12/03/2019

ADDENDUM 02

Project:
Kinesiology Labs and Aquatic Center
Liberal Arts Campus
Long Beach, CA 90806

WW Project No. 16042.01
DSA Application No. 03-119628
File No. 19-C3

PRECAST CONCRETE CAP

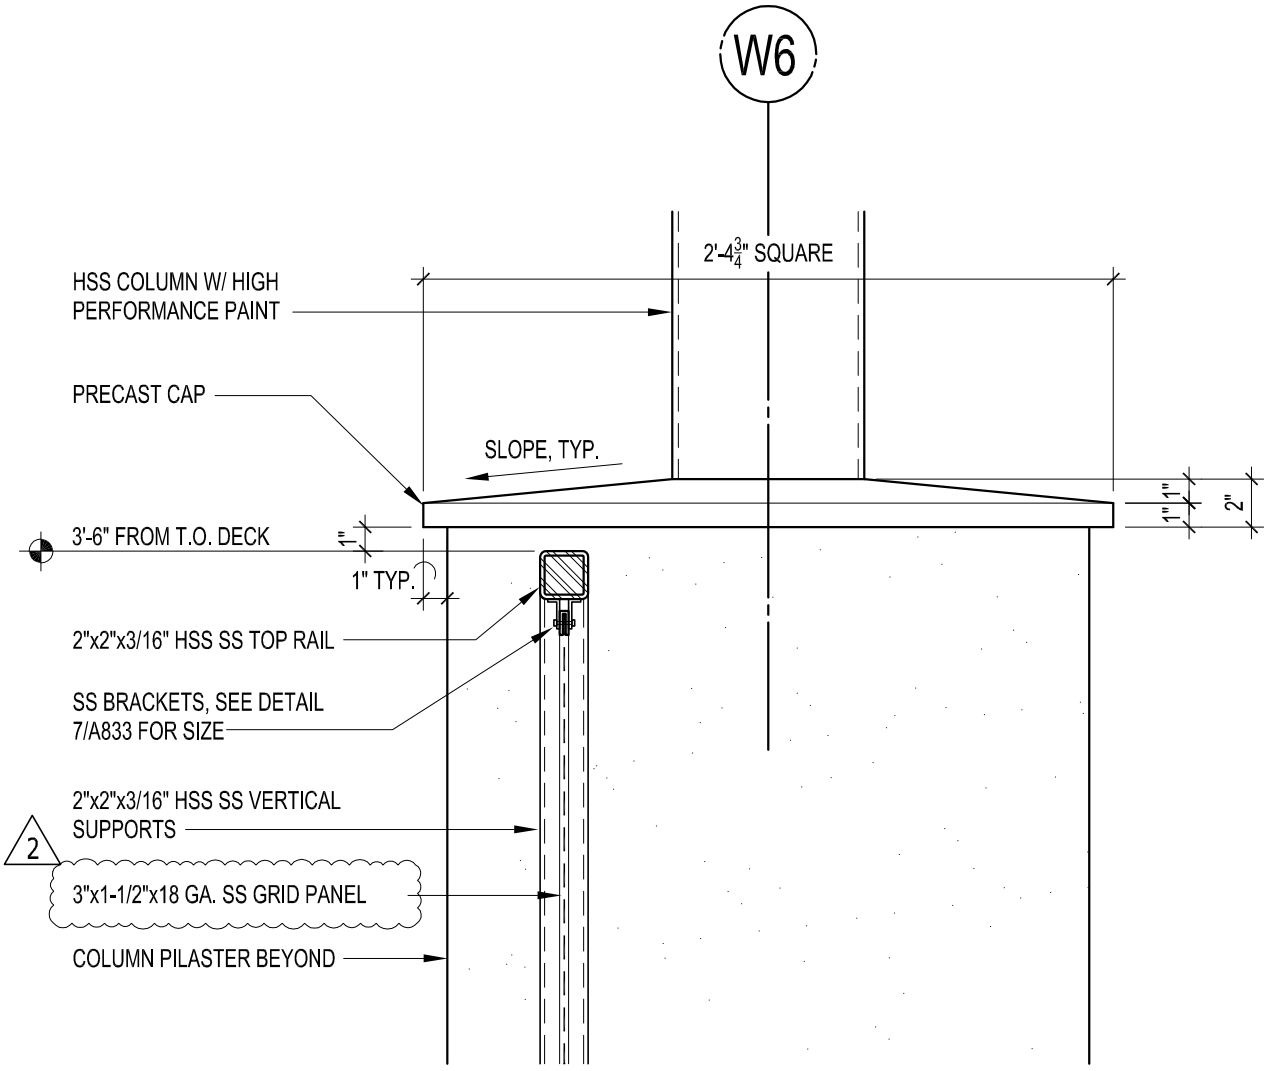
SHEET DESCRIPTION:
REVISED DETAIL 3/A833

GUARDRAIL ELEVATION

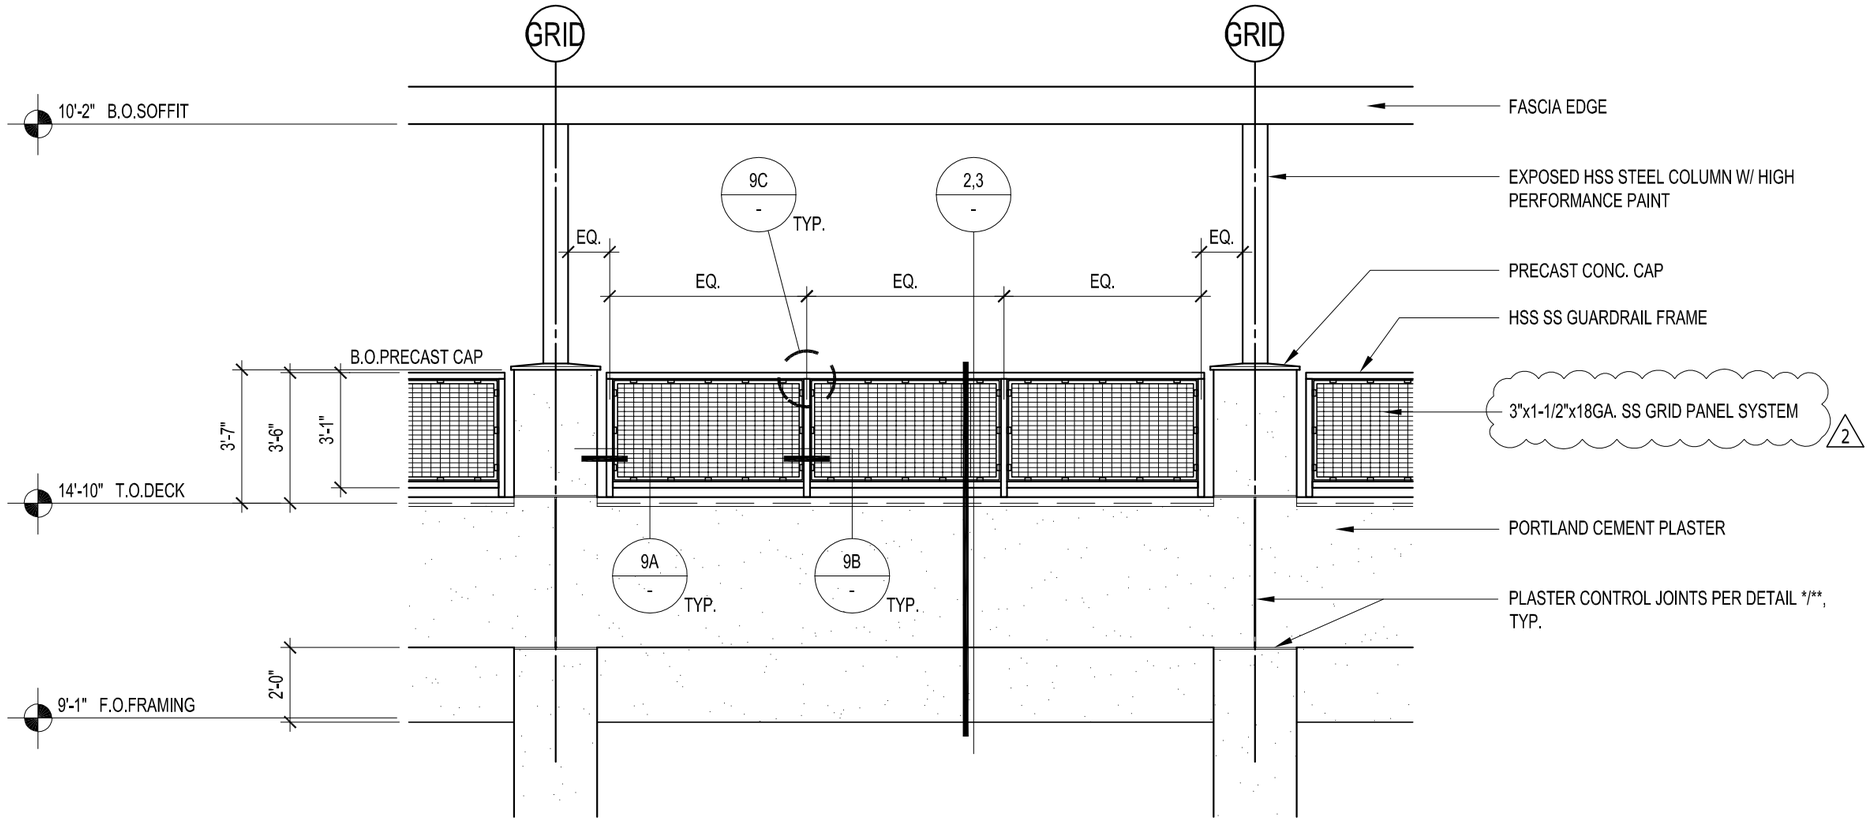
SHEET DESCRIPTION:
REVISED DETAIL 4/A833

GUARDRAIL CONNECTION DETAILS

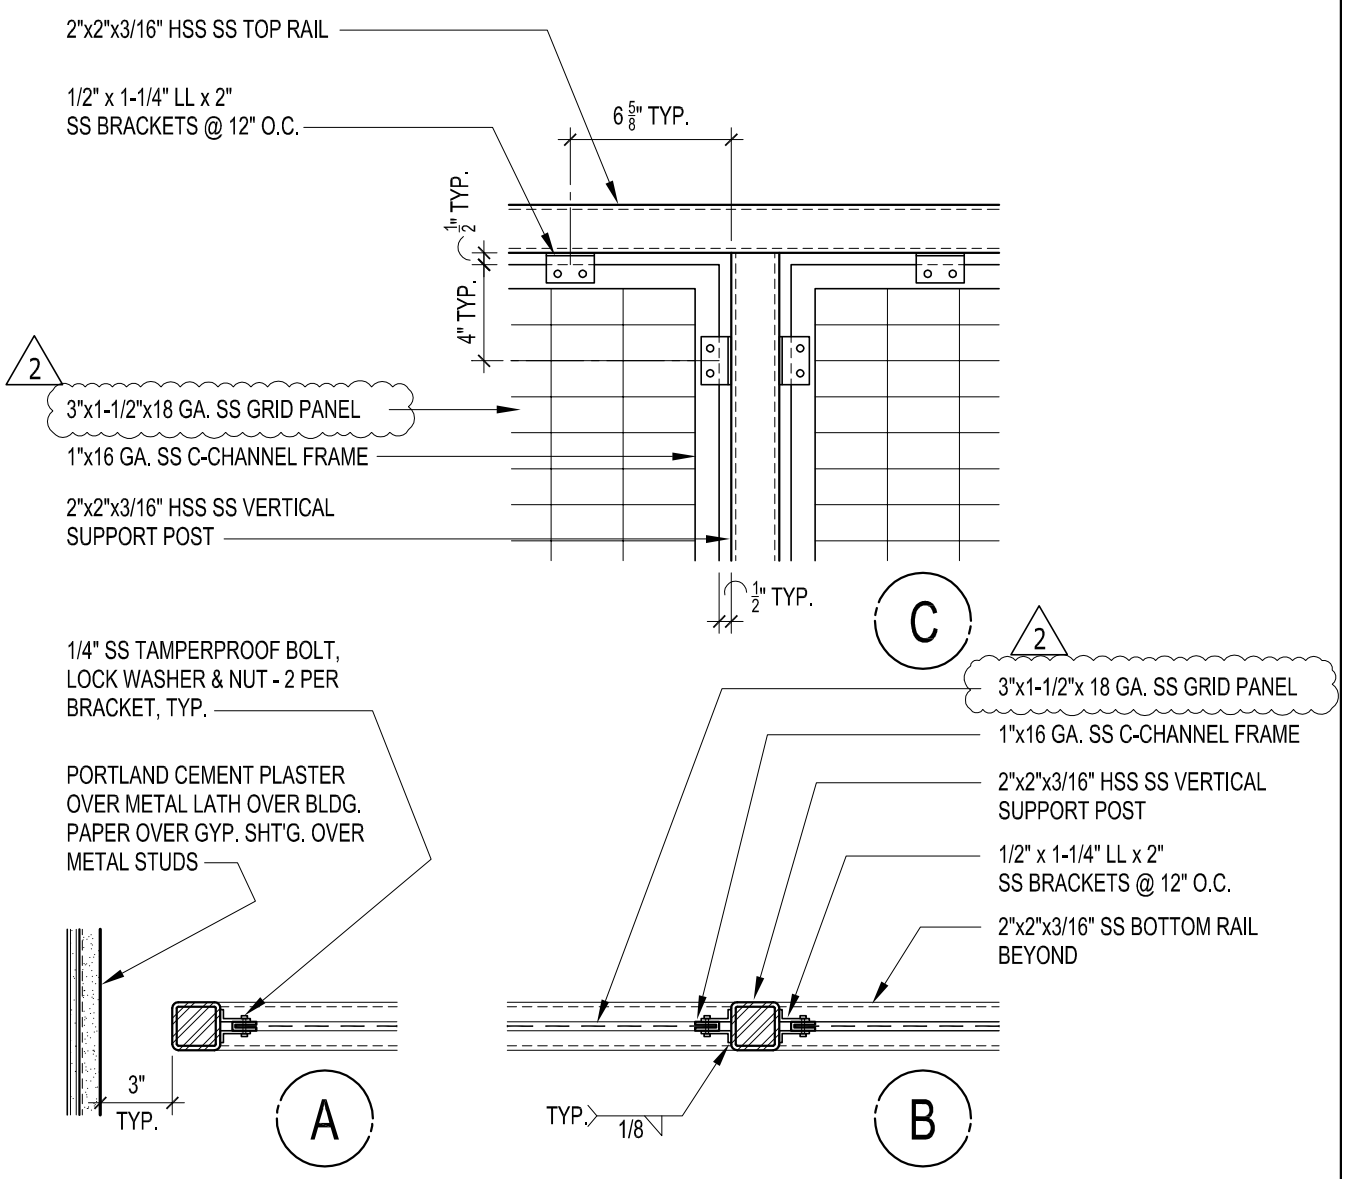
SHEET DESCRIPTION:
REVISED DETAIL 7/A833

ANCHOR ASSEMBLY @
AQUATIC BLEACHERS ONLY

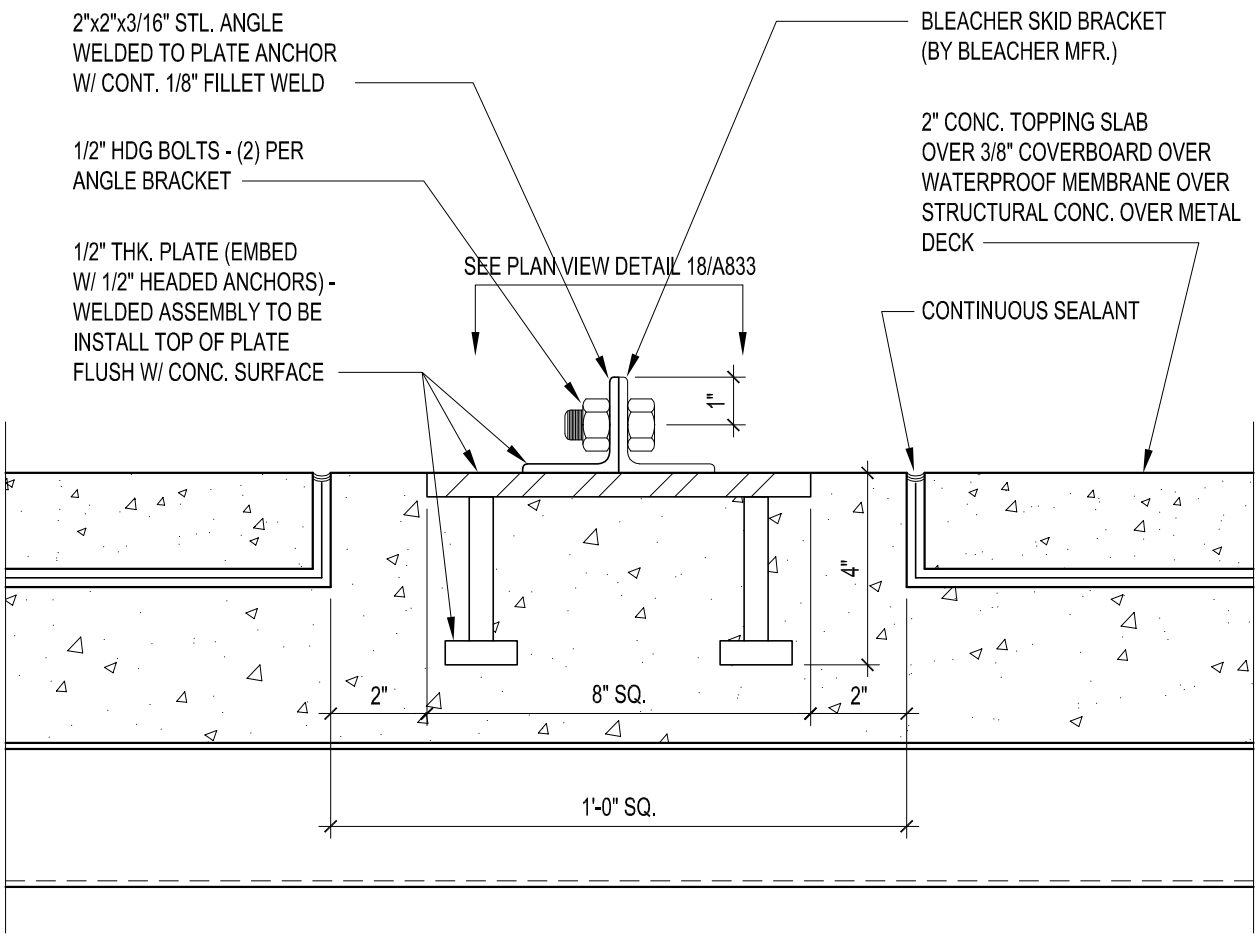
PROVIDE (3) ANCHOR PLATE
ASSEMBLIES @ EA. BLEACHER
SUPPORT FRAME. SUPPORT
FRAMES ARE 6'-0" O.C. PER MFR.

SHEET DESCRIPTION:
NEW DETAIL ON 17/A833

BLEACHER ANCHOR ASSEMBLY

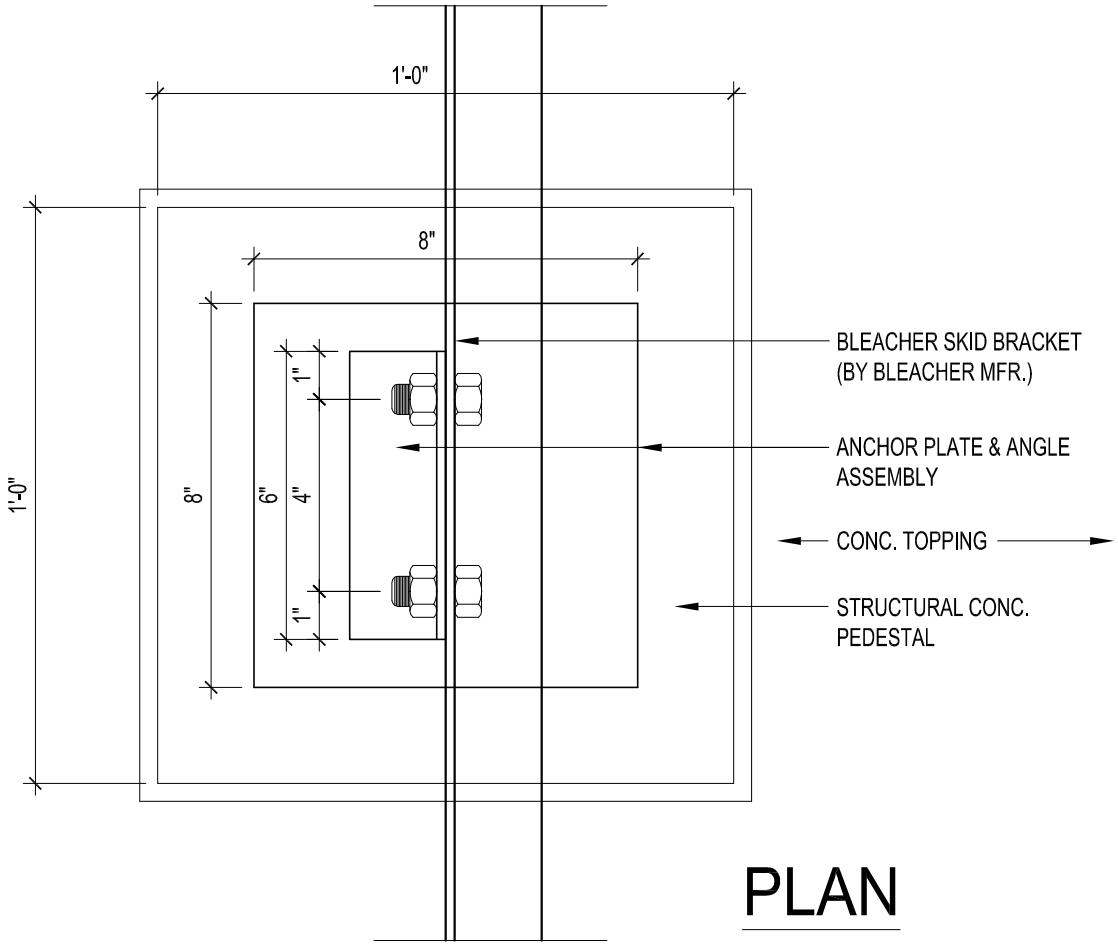
SHEET DESCRIPTION:
NEW DETAIL ON 18/A833

ANCHOR POINTS @ BLEACHER BRACKET

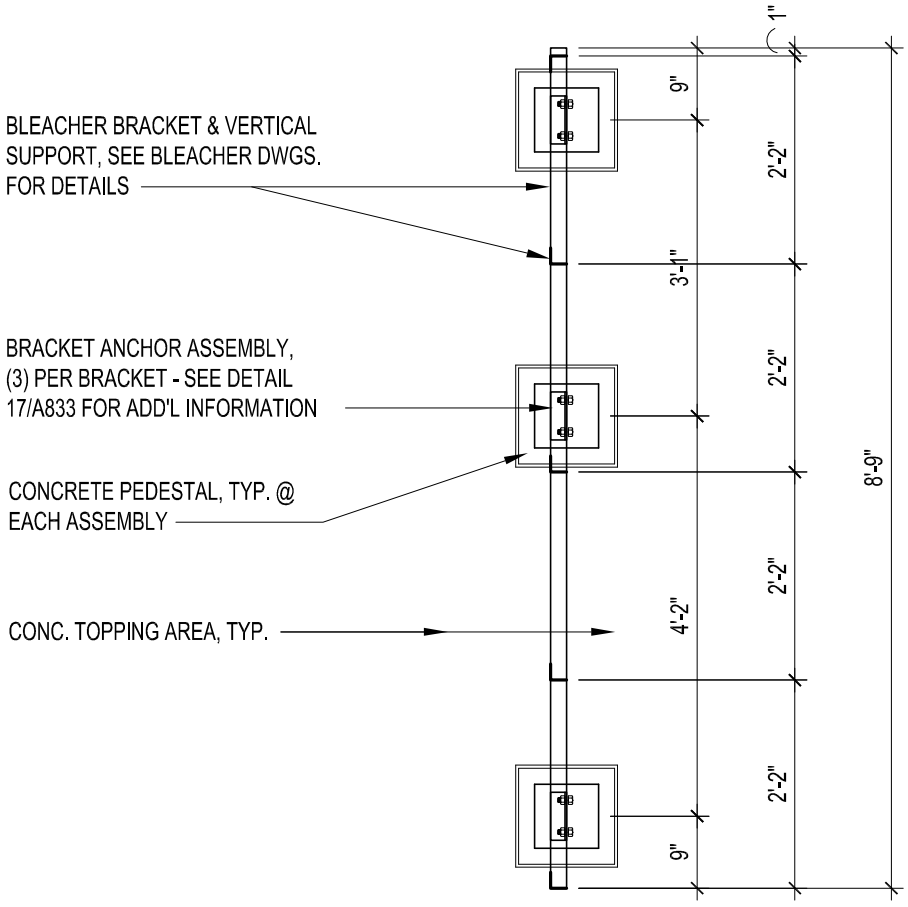
SHEET DESCRIPTION:
NEW DETAIL ON 19/A833

MECHANICAL SCREEN DETAIL

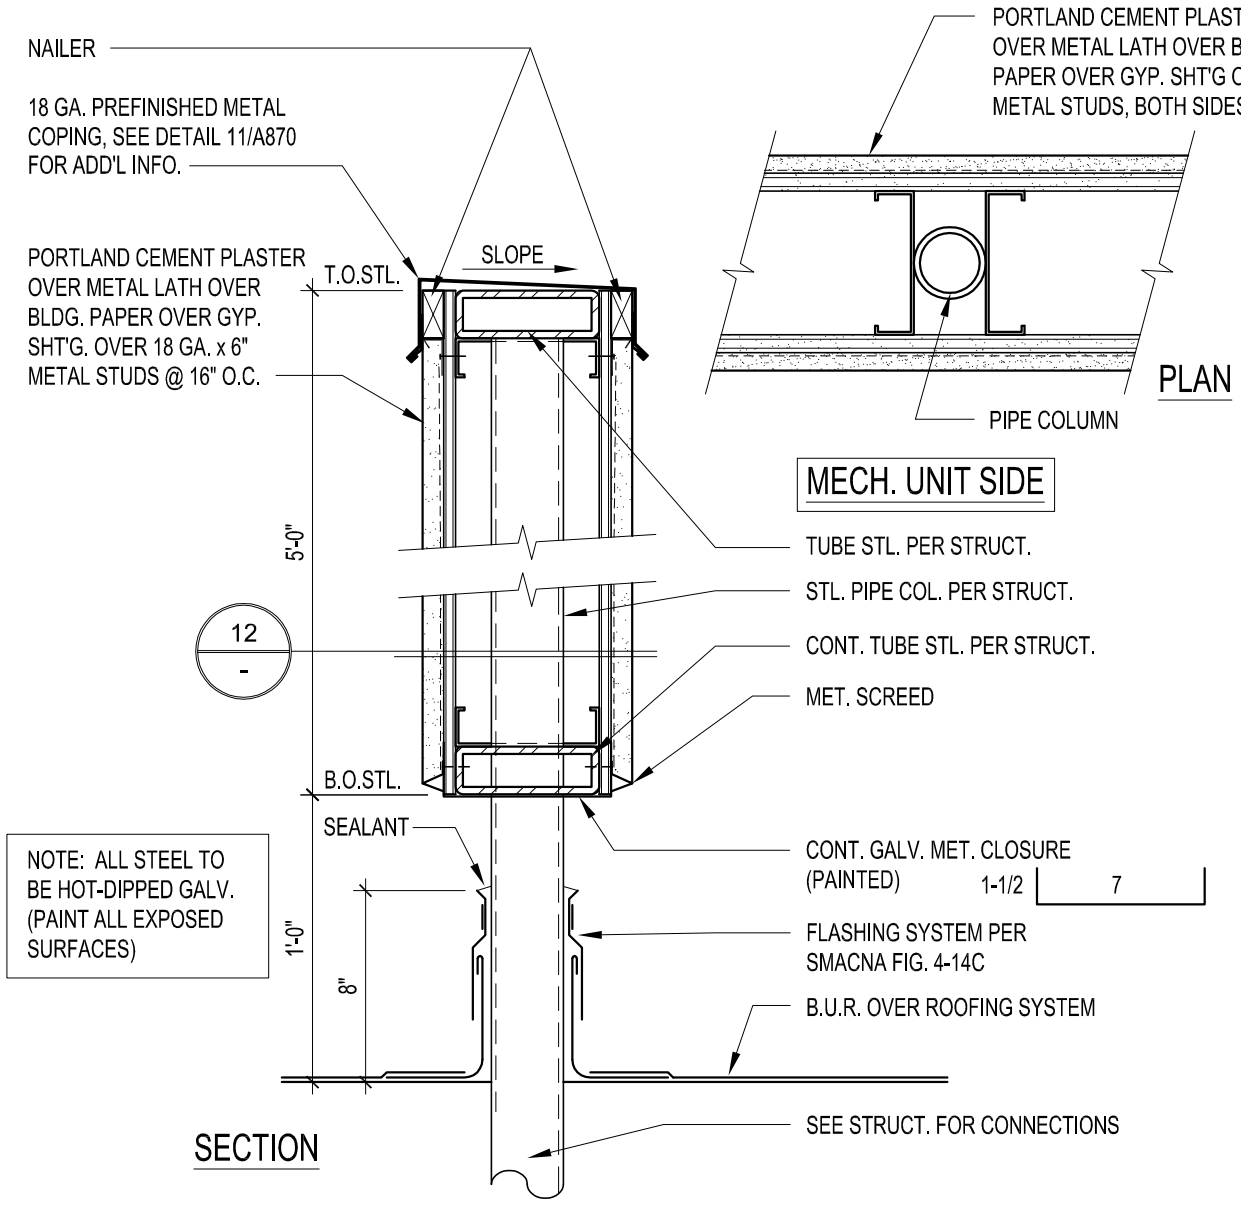
SHEET DESCRIPTION:
NEW DETAIL ON 12/A871

REVISED PARTIAL DETAIL 1/W-S107.2

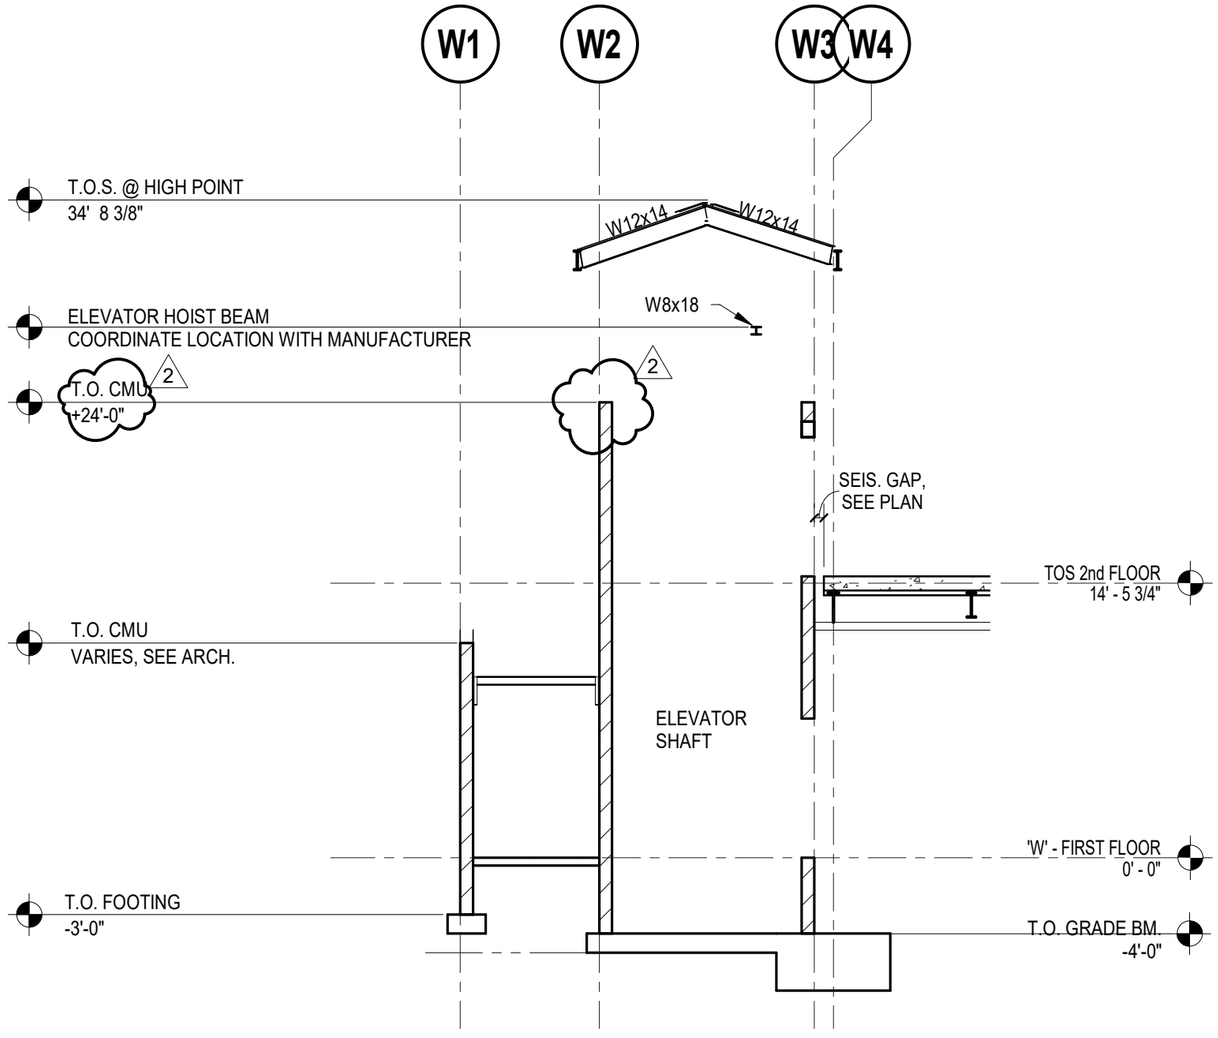
SHEET DESCRIPTION: REVISED PARTIAL DETAIL 1/WS107.2

SHEET DESCRIPTION:
PLUMBING UNDERGROUND PLAN W-P200.1

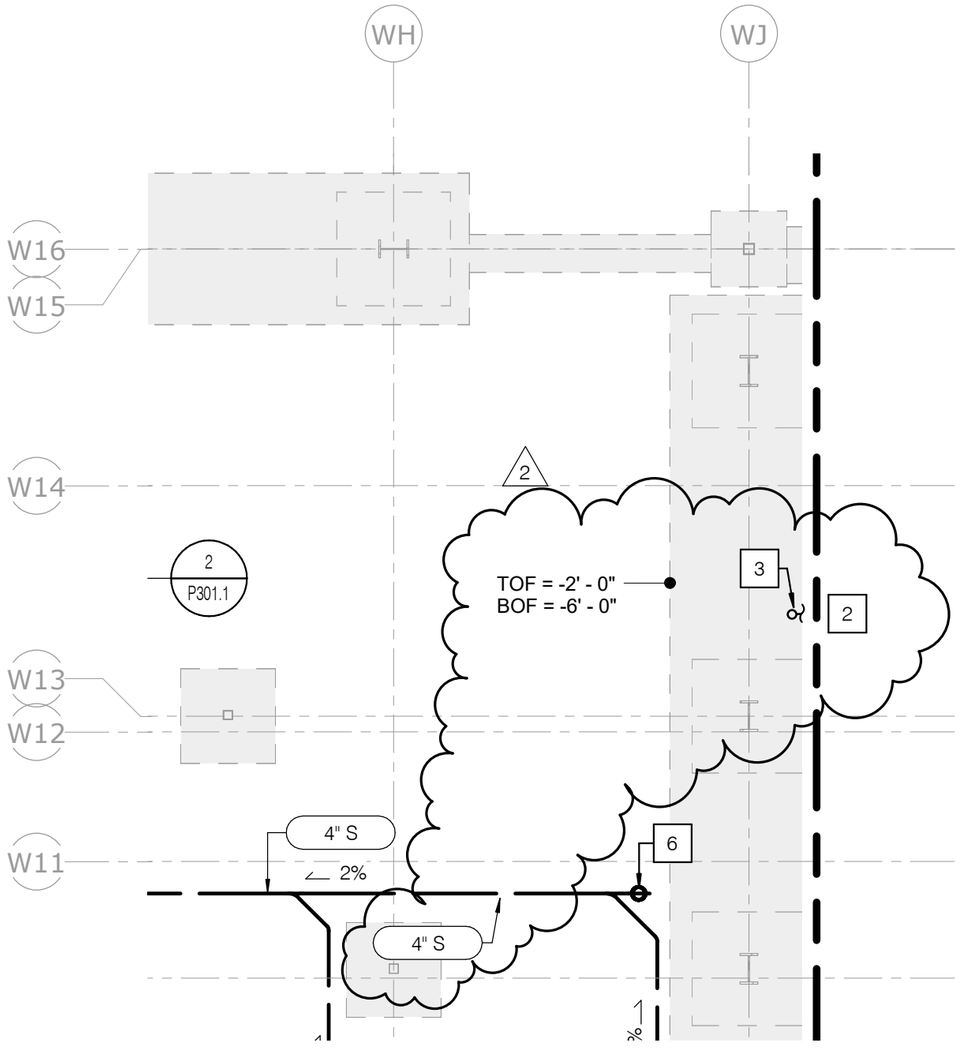
THIS SKETCH MODIFIED DRAWING W-P200.1
